UNITED STATES PATENT AND TRADEMARK OFFICE

10/582,874

Office Action Summary	Application No. 10/582,874	Applicant(s) MORINI, EMILIO	
	Examiner JONATHAN WOOD	Art Unit 4137

DETAILED ACTION

Figure 1, annotated by examiner

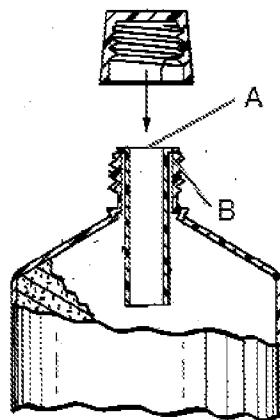
An improved tube made of a plastic material, comprising a lower part (body portion 16) which is open for introduction of a product and closable after the introduction (col. 1, line 57 - col. 2, line 3), and an upper part (tapered shoulder 20) which exhibits a passage-hole (A, Figure 1 below as annotated by examiner) for exit of the product from the tube (col. 2, ll. 25-27), the upper part comprising an opening (B, Figure 1 below as annotated by examiner), which is larger than the passage-hole (Figure 1) and is arranged in a zone of the upper part in which the passage-hole is to be made (Figure 1); the tube comprising a reducer element (insert 28) in which the passage-hole is made, which reducer element is conformed and arranged in order to fit sealingly in the opening (col. 2, ll. 9-14); characterized in that it comprises a threaded mouth (neck 22) having a cylindrical shape and onto which a closure cap (cap 38) is screwed (col. 2, ll. 20-24), at which threaded mouth the opening is afforded (Figure 1), the reducer element comprising a disc (outwardly directed annular flange 33)

which rests superiorly on the threaded mouth when the reducer element is fitted into the opening (Figure 1).

Nimmey fails to disclose:

The reducer element having a film on an upper part of the disc in order to close the passage-hole.

It would have been obvious to one having ordinary skill in the art at the time of the invention to have manufactured the tube of *Nimmey* with a film over its opening as taught by *Yoshida* in order to keep the tube sealed between manufacture and usage. Applying the teaching of *Yoshida* to the tube of *Nimmey* would necessitate the film being applied over the reducer element passage-hole which is inserted into the main opening of the tube.
